ADDENDUM NO. 1

Date: **February 9, 2024**
Issued by: **Sacramento City Unified School District**
Project: **Project #0410-409-1 Albert Einstein MS Modernization**

KITCHEN
 DEMOLITION PLANS

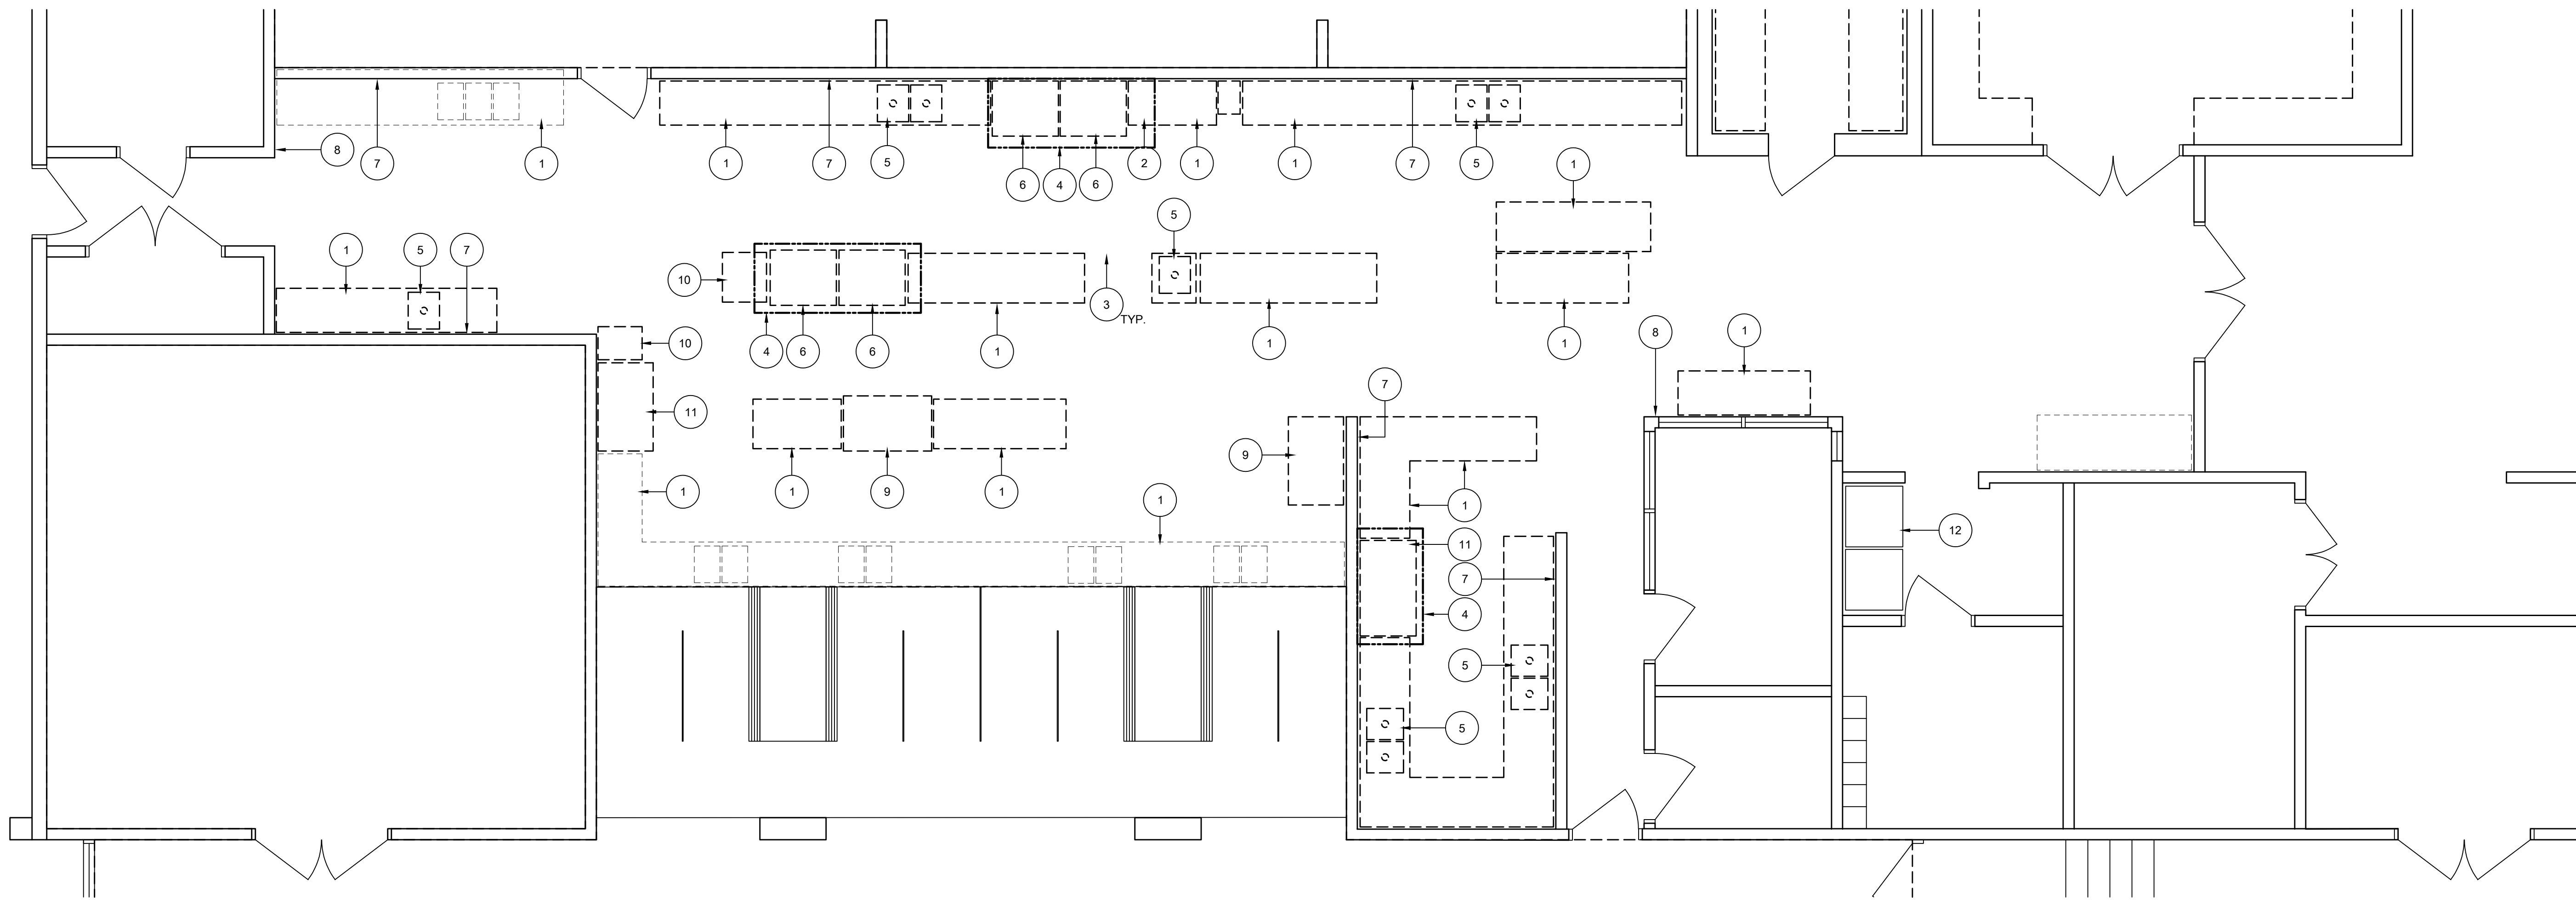
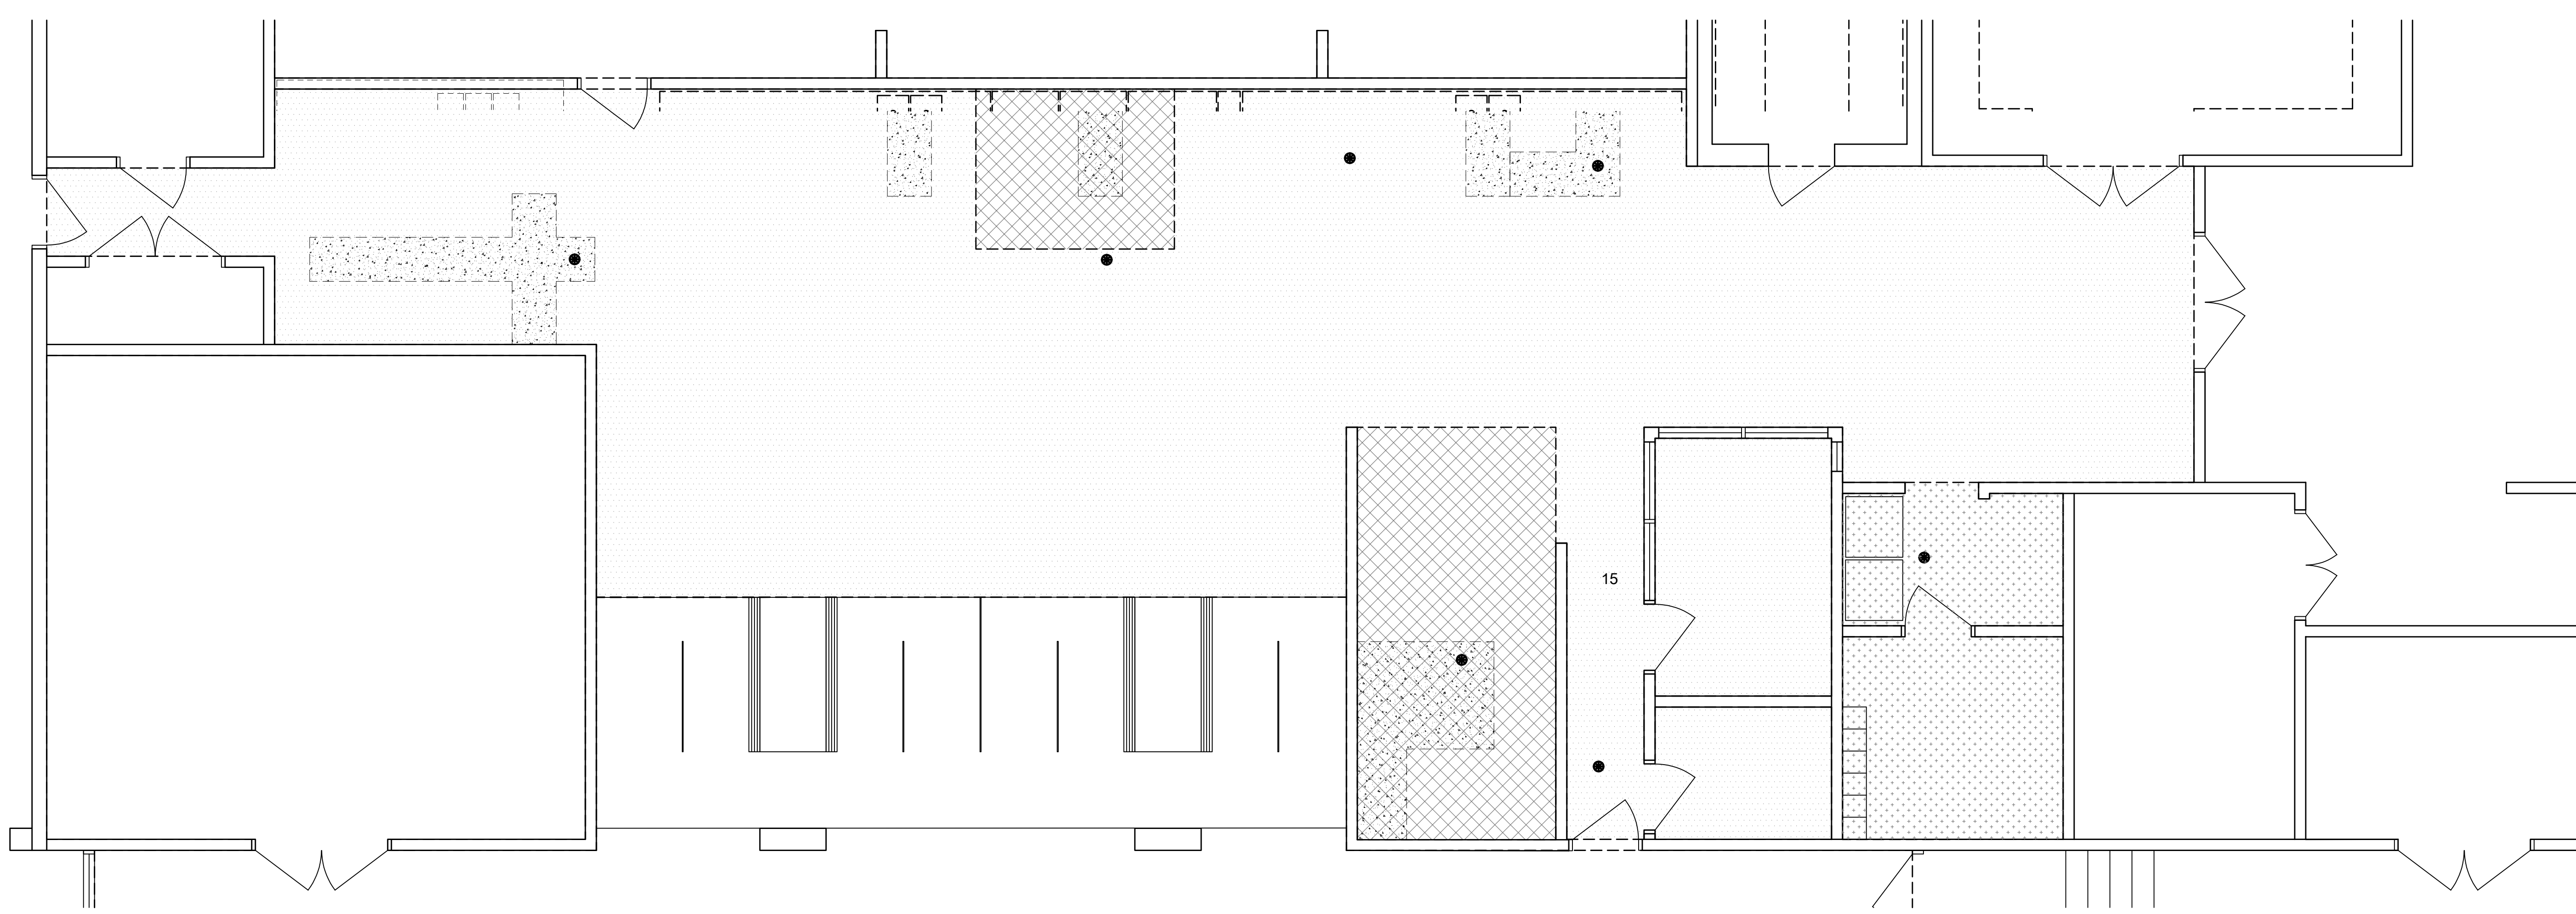
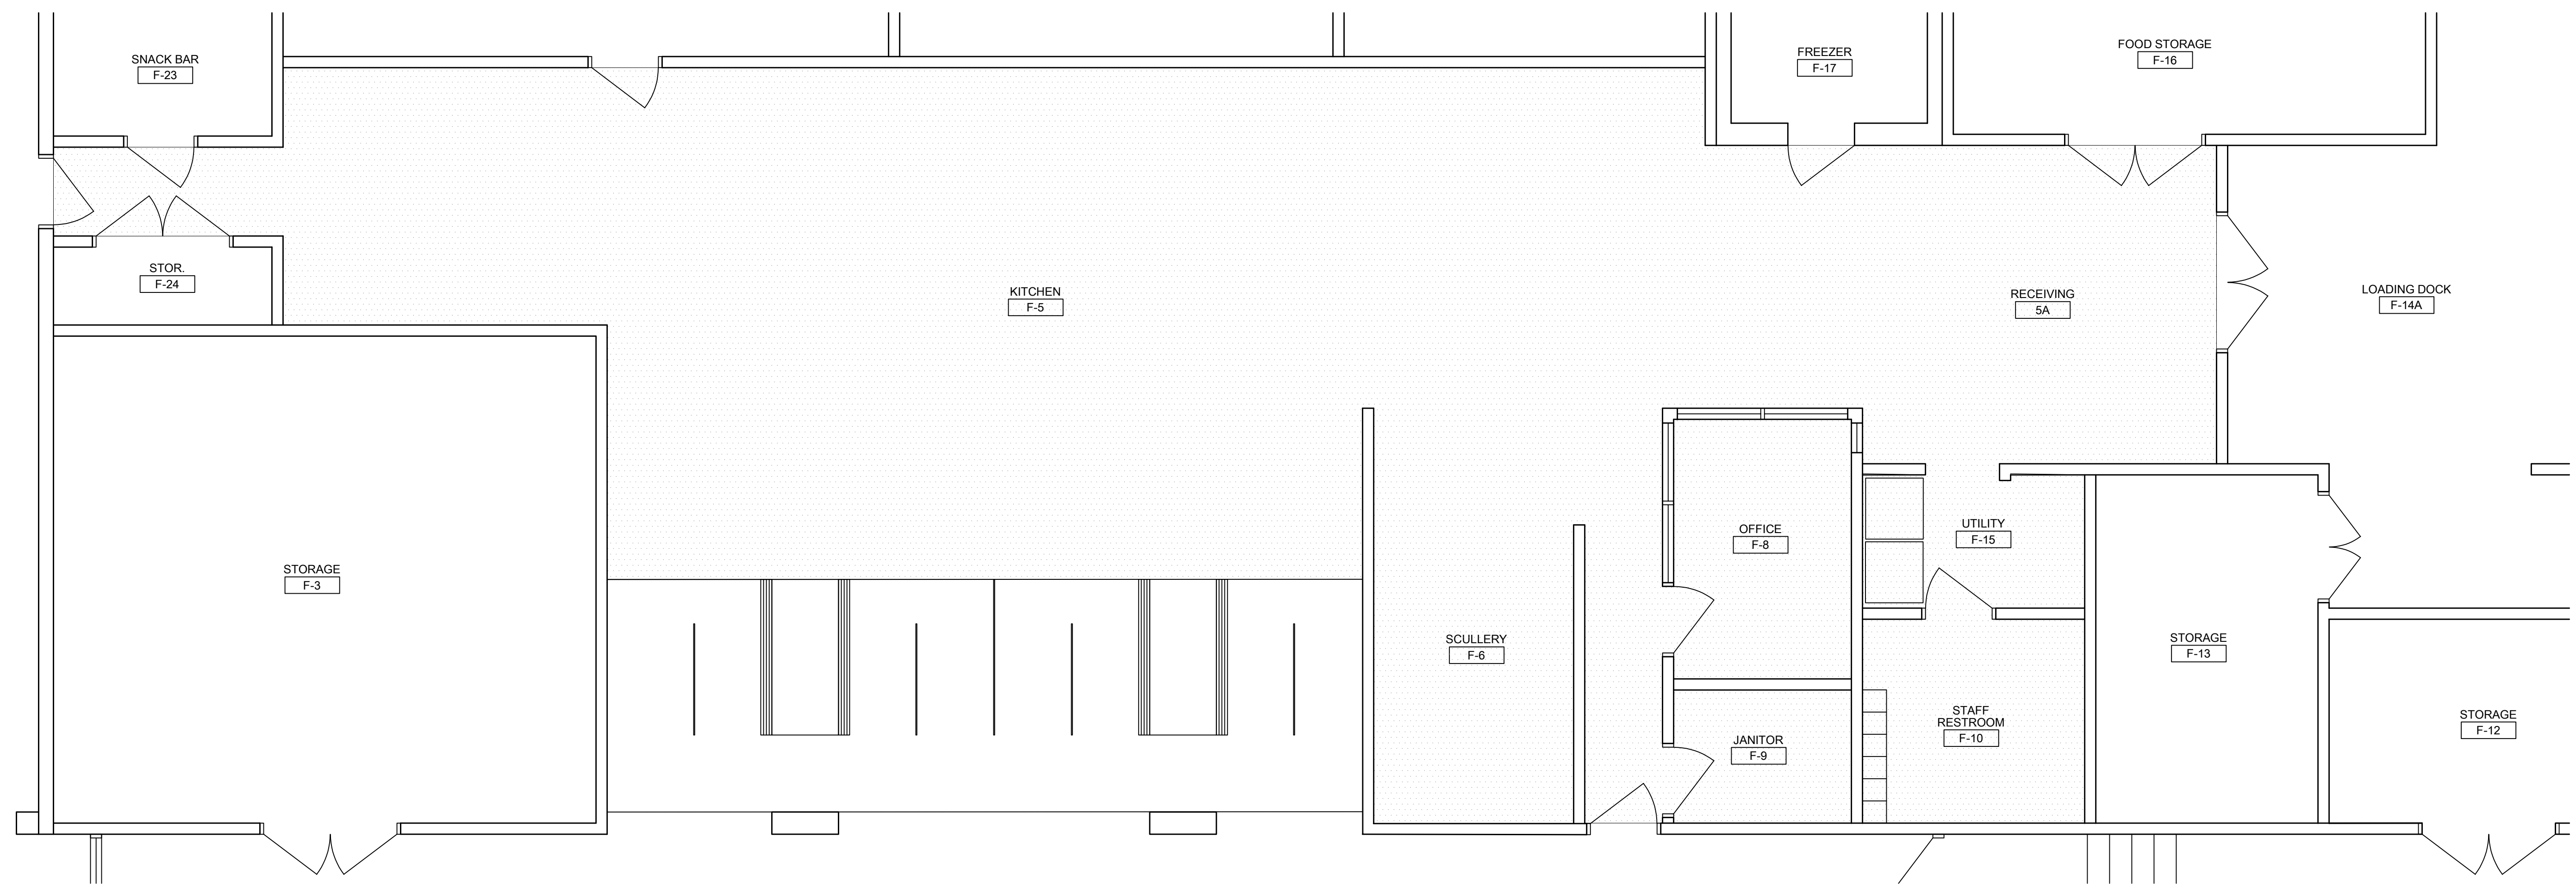
Addendum Item No. AD1.16- A134D Kitchen Demolition Plans (Package A)

- Added showing demolition of existing flooring finishes and areas where concrete will need to be trenched to connect underground utilities. Additional equipment demolition plan showing what equipment is to be demolished and what is to be removed and reinstalled upon completion of work. See addendum drawing number AD01.16.

Q#39: Package A - Sheet A134D, flooring legend shows "Demo of entire epoxy coated concrete slab or tile flooring and covered base wall-to-wall in order to replace all underground utilities as shown on plumbing drawings. On the job walk it we mentioned that the slab in the kitchen does not get removed. Please advise.

R#39: *See revised sheet AD01.16 included in this addendum.*

28 KITCHEN NEW FLOORING
 SCALE: 1/4" = 1'-0"

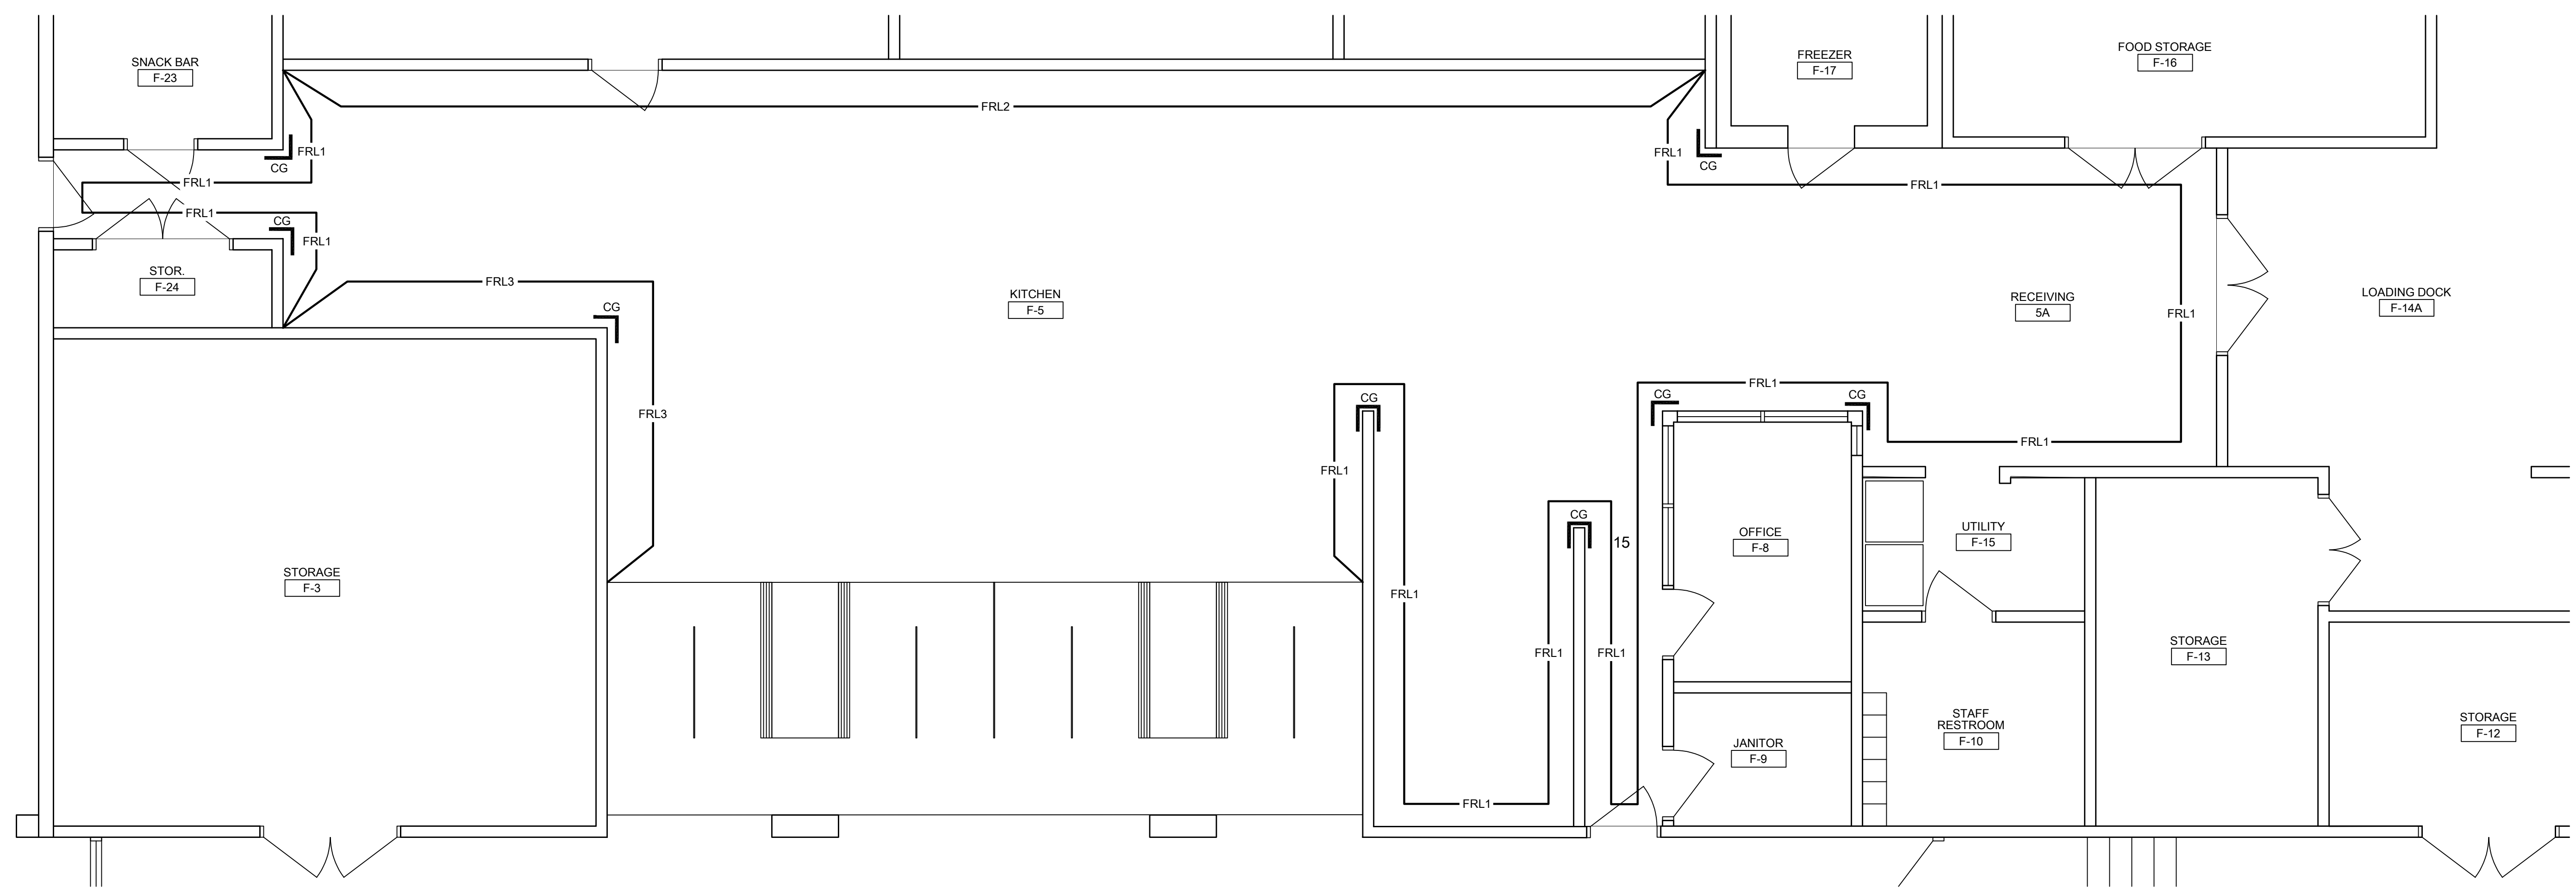
Addendum Item No. AD1.17- A134 Kitchen New Work Plans (Package A)

- Added addendum drawing number AD01.17. showing the extent of new epoxy flooring system and new FRL layout plan.
